To: INCITS T10 Committee
 From: Susan Gray, Quantum
 Date: March 8, 2004
 Document Number: T10/04-056r3
 Subject: ADT Link service error recovery

replace existing Figure 5 Link Negotiation state diagram with the following diagram

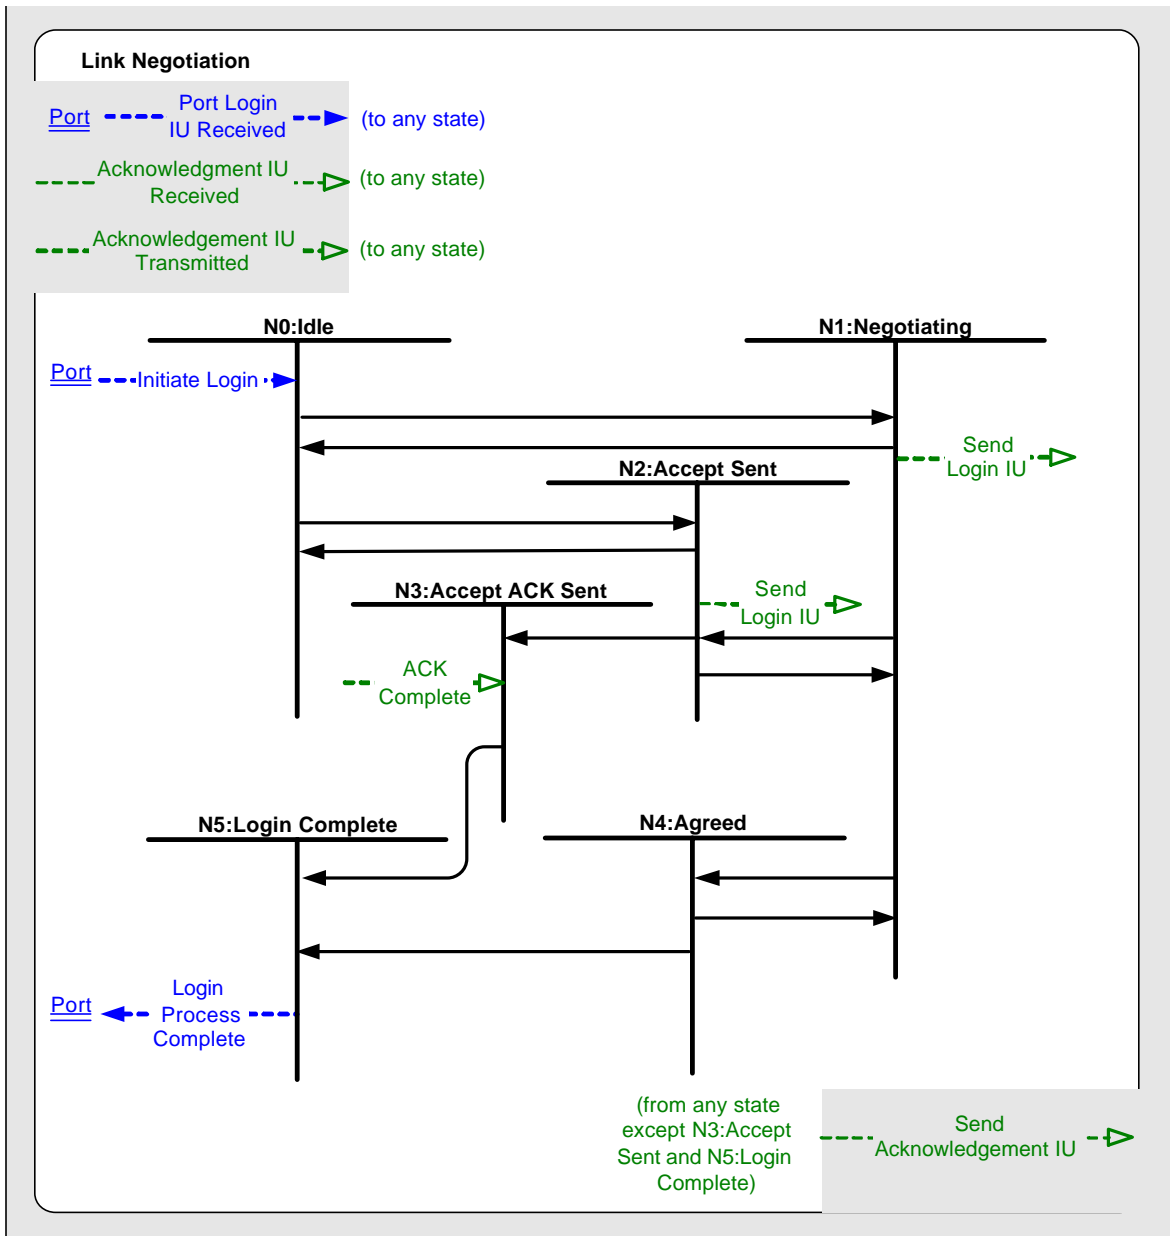
Add N5:Login complete state to handle the successful completion of the login process and allows N0:Idle to be used for error cases.

Globally change N4:Complete to N4:Agreed

- f) N5:Login Complete
